**STAFF REPORT
KETCHUM PLANNING AND ZONING COMMISSION
SPECIAL MEETING OF MARCH 30, 2021**

PROJECT: Deep Powder Townhomes

APPLICATIONS: Mountain Overlay Design Review (File No. P21-018) & Townhouse Subdivision Preliminary Plat (File No. P21-017)

STAFF REPORT
KETCHUM PLANNING AND ZONING COMMISSION
SPECIAL MEETING MARCH 23, 2021

Sheet No:
L3.0

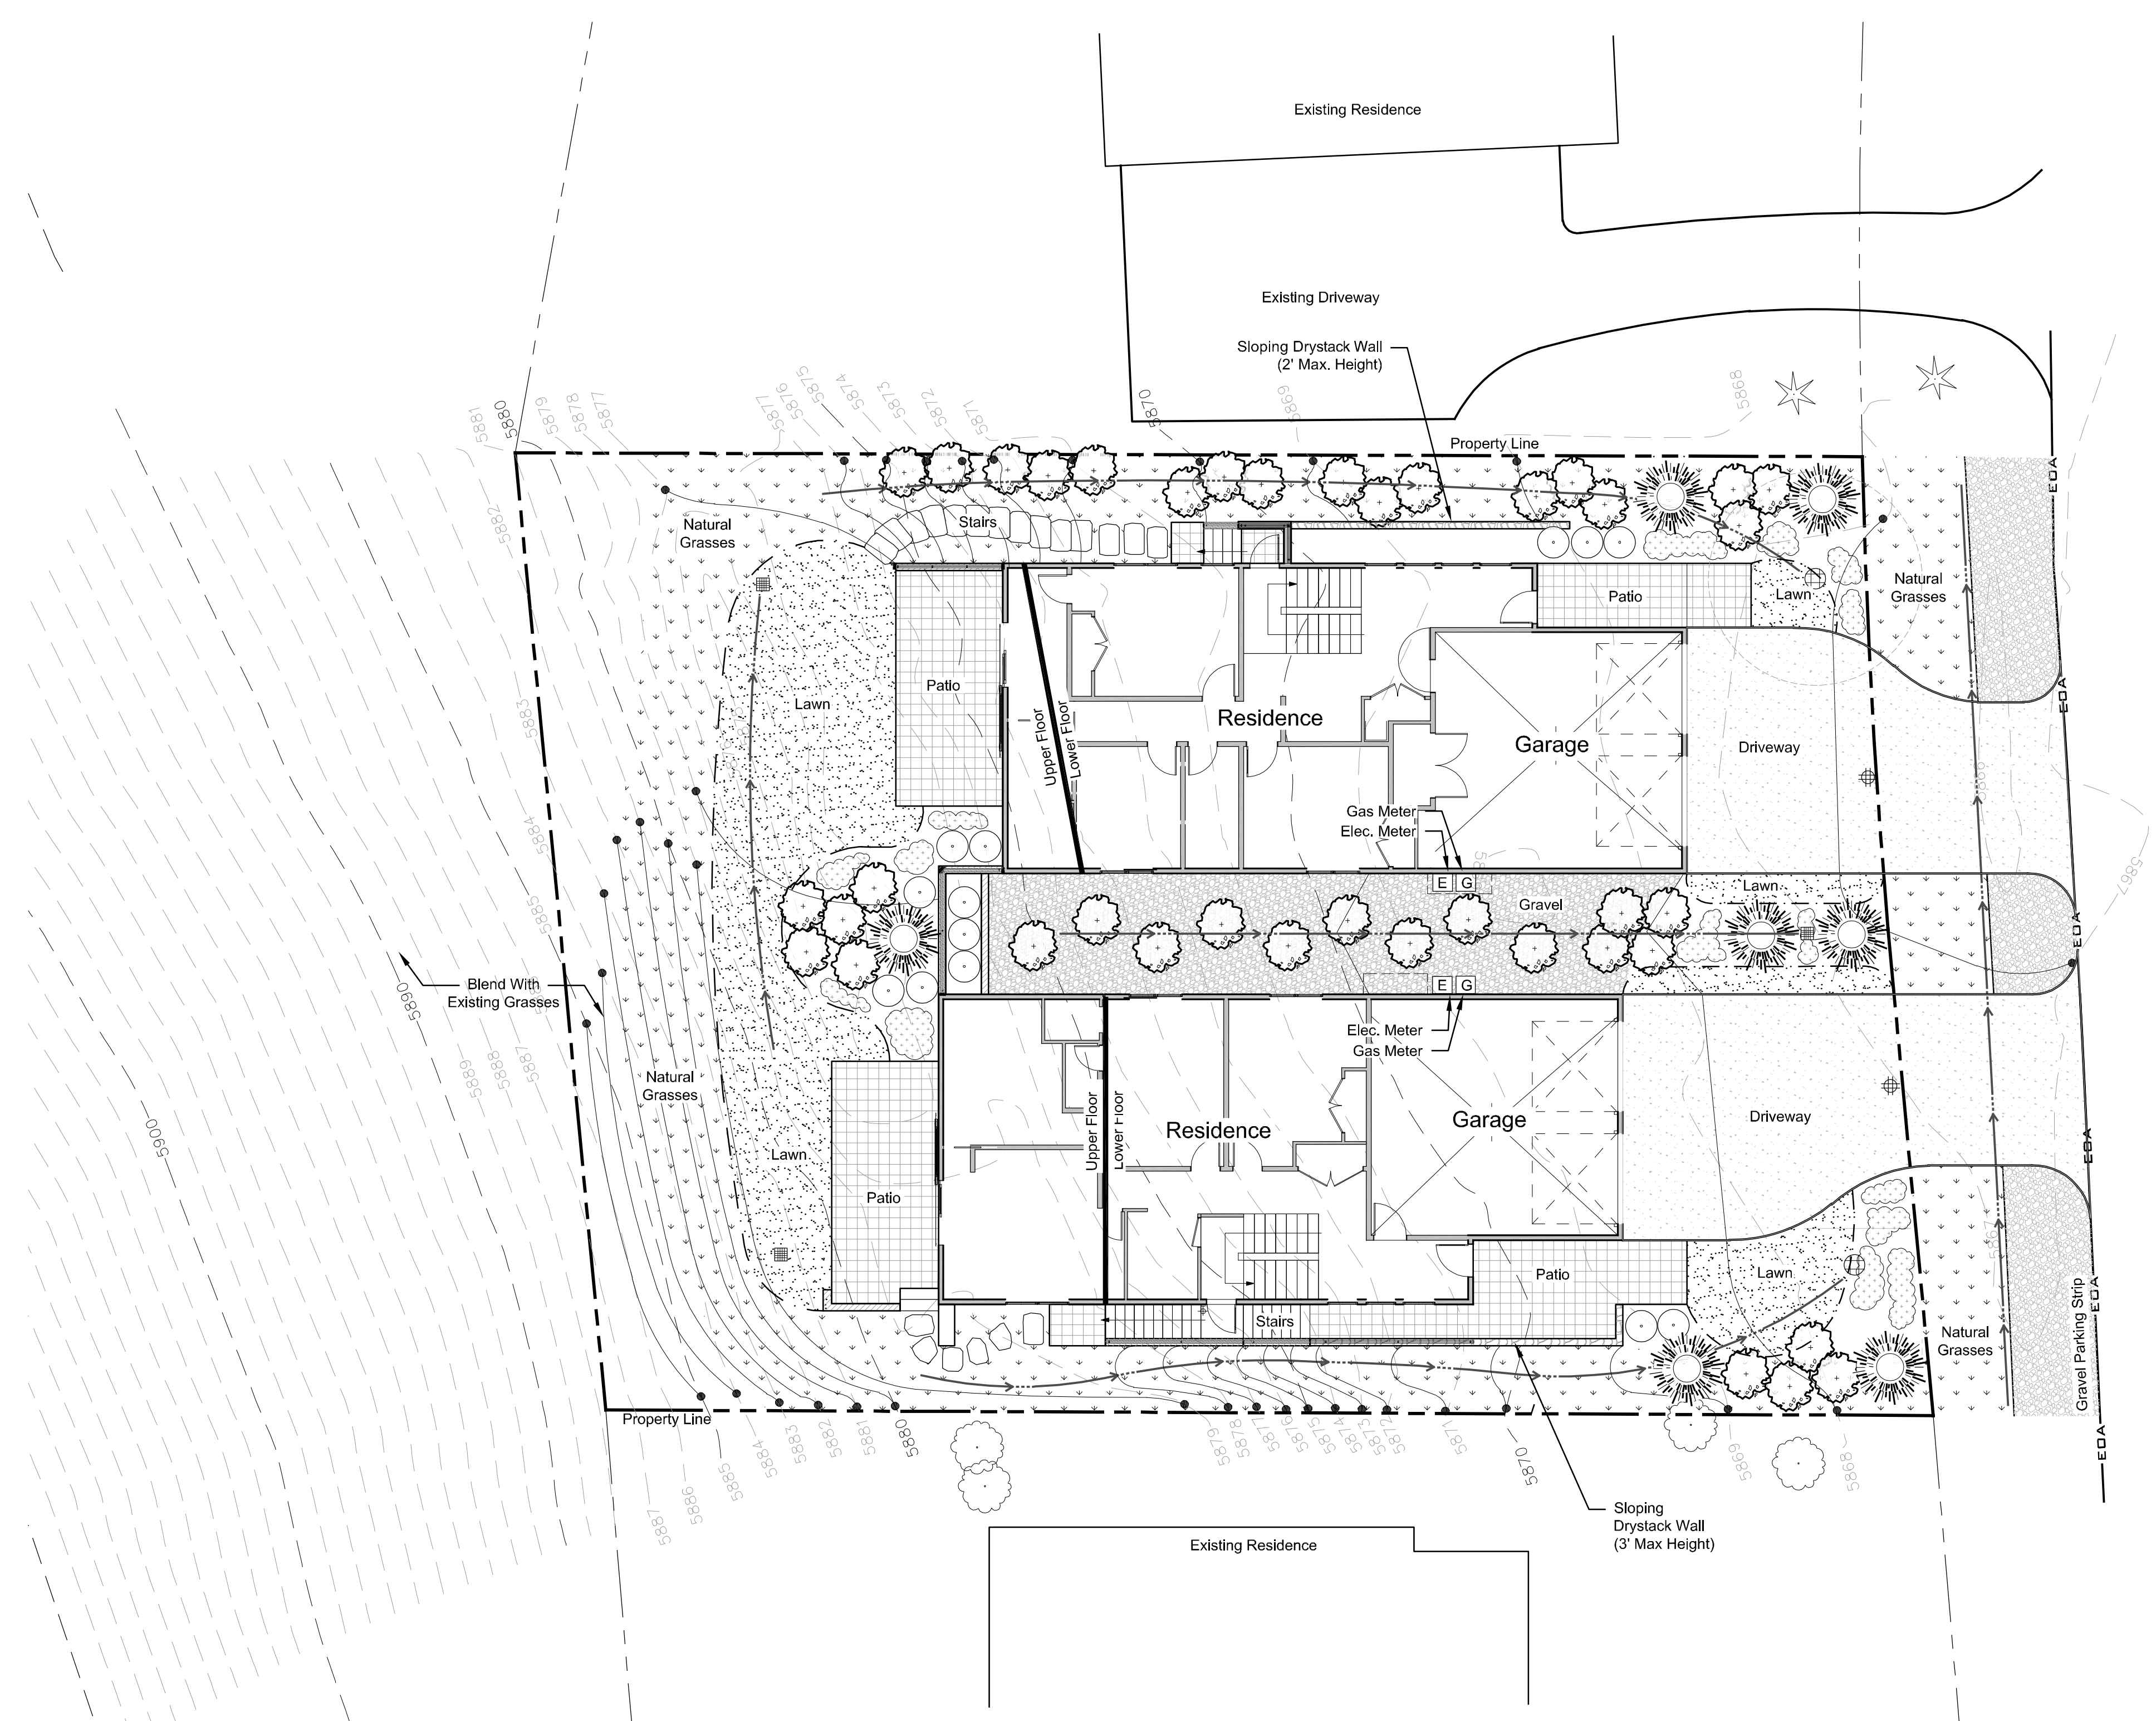
<i>Staff Comments</i>	<i>See sheet L3.0.</i>
	<input type="checkbox"/>	<input type="checkbox"/>	17.96.060(I)(2)	Landscape materials and vegetation types specified shall be readily adaptable to a site's microclimate, soil conditions, orientation and aspect, and shall serve to enhance and complement the neighborhood and townscape.
			<i>Staff Comments</i>	<i>The applicant proposes to use a natural grass mix for the majority of the property and a limited amount of lawn (1,000 square feet). The proposed evergreen trees (Colorado Spruce) and deciduous trees (Quaking Aspen) are common in the vicinity and throughout Ketchum.</i>
	<input type="checkbox"/>	<input type="checkbox"/>	17.96.060(I)(3)	All trees, shrubs, grasses and perennials shall be drought tolerant. Native species are recommended but not required.
			<i>Staff Comments</i>	<i>The applicant proposes to use a natural grass mix for the majority of the property and a limited amount of lawn (1,000 square feet). The proposed evergreen trees (Colorado Spruce) and deciduous trees (Quaking Aspen) are drought tolerant once established, with Colorado Spruce being among the most drought-tolerant species of spruces.</i>

Staff Comments	N/A.
<input checked="" type="checkbox"/>	<input type="checkbox"/>	<input type="checkbox"/>	17.96.060(I)(1)	Landscaping is required for all projects.
			Staff Comments	See sheet L3.0.
<input checked="" type="checkbox"/>	<input type="checkbox"/>	<input type="checkbox"/>	17.96.060(I)(2)	Landscape materials and vegetation types specified shall be readily adaptable to a site's microclimate, soil conditions, orientation and aspect, and shall serve to enhance and complement the neighborhood and townscape.
			Staff Comments	The applicant proposes to use a natural grass mix for the majority of the property and a limited amount of lawn (1,000 square feet). The proposed evergreen trees (Colorado Spruce) and deciduous trees (Quaking Aspen) are common in the vicinity and throughout Ketchum.
<input checked="" type="checkbox"/>	<input type="checkbox"/>	<input type="checkbox"/>	17.96.060(I)(3)	All trees, shrubs, grasses and perennials shall be drought tolerant. Native species are recommended but not required.

Staff Comments	The applicant proposes to use a natural grass mix for the majority of the property and a limited amount of lawn (1,000 square feet). The proposed evergreen trees (Colorado Spruce) and deciduous trees (Quaking Aspen) are drought tolerant once established, with Colorado Spruce being among the most drought-tolerant species of spruces.
<input checked="" type="checkbox"/>	<input type="checkbox"/>	<input type="checkbox"/>	17.96.060(I)(4)	Landscaping shall provide a substantial buffer between land uses, including, but not limited to, structures, streets and parking lots. The development of landscaped public courtyards, including trees and shrubs where appropriate, shall be encouraged.
			Staff Comments	Residential development exists on both sides of the subject property and therefore a substantial landscape buffer along all property sides is not required. The applicant has broken up the impact of the driveway curb-cuts by siting landscaping (evergreen trees) in between the two proposed driveways.
